DEPARTMENT OF TRANSPORTATION**Federal Aviation Administration****14 CFR Part 36**

[Docket No. FAA-1998-4731; Amendment No. 36-22]

Noise Certification Standards for Propeller-Driven Small Airplanes

ACTION: Final rule.

MEASUREMENT WINDOW FOR NO ABSORPTION CORRECTION
Figure G1

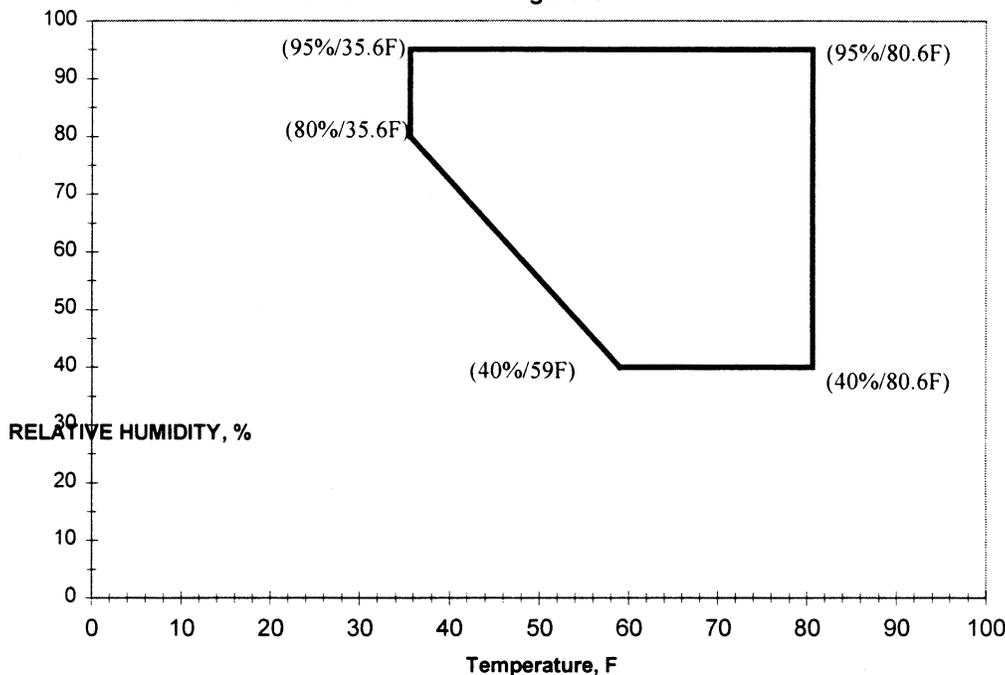
Current § G36.201(b) requires atmospheric absorption correction for noise data obtained when the test conditions are outside those specified in appendix G, figure G1. Noise data collected outside the prescribed range of figure G1 are required to be corrected to 77 degrees Fahrenheit and 70 percent relative humidity by an FAA approved method. The FAA proposed changing the 77 degrees Fahrenheit reference temperature to 59 degrees Fahrenheit, to be consistent with the ambient temperature requirement in current § G36.111(b)(2), that is used for performance calculations.

Aeromod Services, Inc. objects to changing the 77 degree Fahrenheit reference temperature to 59 degree Fahrenheit in paragraph (b) because it "harmonizes in the wrong direction." The commenter says that the section should be "placed on the list for JAR 36 harmonization with FAR 36."

If we examine the existing FAA and ICAO noise rules, we find that the only rule which does not have a primary or absolute acoustical reference day defined by 77°F/70%RH is Annex 16, Chapter 10. All of the other noise rules, to include FAR 36 Appendix A, Current Appendix G, Appendix H, ICAO Annex 16 Chapter 3, Chapter 4, and Chapter 8, use 77°F/70%RH as the primary or absolute acoustical reference day.

Aeromod comments that the only section of part 36 which does not have both the performance and acoustic reference day conditions as 77 degree Fahrenheit and 70 percent relative humidity is Appendix G. The reason for this apparent inconsistency is based on the different noise characteristics of other airplane classes, namely large transports and helicopters. Propeller-driven small airplane noise levels are dominated by the low frequency tone noise under 500 Hz. Other classes of airplanes have noise characteristics that can be concentrated at higher frequencies. This difference in noise characteristics is reflected in the regulations by the different atmospheric absorption correction requirements for each class of airplanes.

(b) Atmospheric absorption correction is required for noise data obtained when the test conditions are outside those specified in Figure G1. Noise data outside the applicable range must be corrected to 59 F and 70 percent relative humidity by an FAA approved method.

**NOISE LEVELS vs AIRPLANE WEIGHT
FIGURE G2**

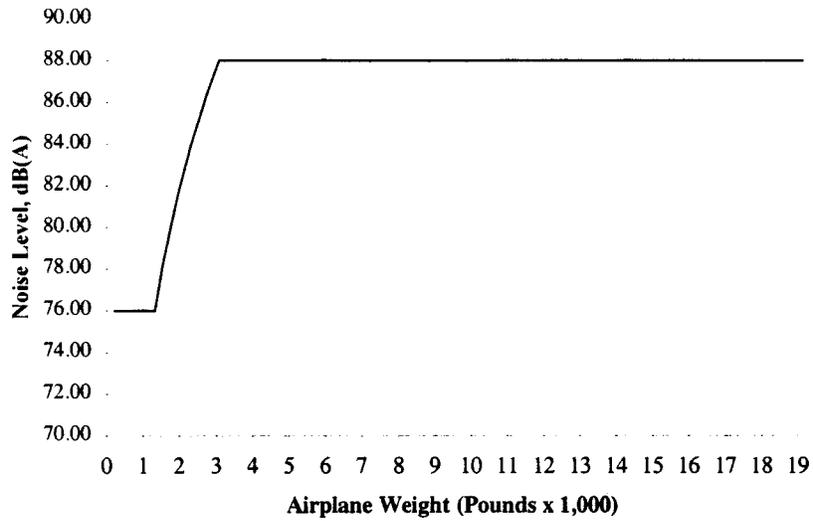
Current § G36.301(b) states that for aircraft weights up to 1,320 pounds (600 kg) the noise level must not exceed 73 dB(A); for weights greater than 1,320 pounds, the noise limit increases at the rate of 1 dB /165 pounds up to 85 dB(A) at 3,300 pounds, after which the noise level remains constant at 85 dB(A) up to and including aircraft weight of 19,000 pounds.

As previously discussed, considerations of microphone location, configuration, and resulting noise limits are interrelated. Since the proposed changes to the noise measurement procedures of § G36.107(a) would result in increases in the measured noise levels of about 3 dB(A), the FAA proposed to increase the limits in § 36.301(b) from 73 dB(A) to 76 dB(A) and from 85 dB(A) to 88 dB(A) to account for these different measurement procedures, but without changing the stringency of the current rule.

In addition to the dB(A) increases discussed, the FAA proposed a change to the interpolation requirement of § G36.301(b). For airplane weights greater than 1,320 pounds, the allowable

dB(A) would increase "with the logarithm of airplane weight at the rate of 9.83 dB(A) per doubling of weight until the limit of 88 dB(A) is reached * * *," rather than at the rate of 1 dB/165 pounds up to 85 dB(A) at 3,300 pounds, as under the current rule. The new logarithmic interpolation between the low and high takeoff weights was adopted from the Annex 16, Volume I Chapter 10. The working group analyzed the available data obtained by use of a ground microphone, and decided to adopt the logarithmic interpolation that is between low and high takeoff weights.

(b) The noise level must not exceed 76 dB (A) up to and including aircraft weights of 1,320 pounds (600 kg). For aircraft weights greater than 1,320 pounds, the limit increases from that point with the logarithm of airplane weight at the rate of 9.83 dB (A) per doubling of weight, until the limit of 88 dB (A) is reached, after which the limit is constant up to and including 19,000 pounds (8,618 kg). Figure G2 shows noise level limits vs airplane weight.
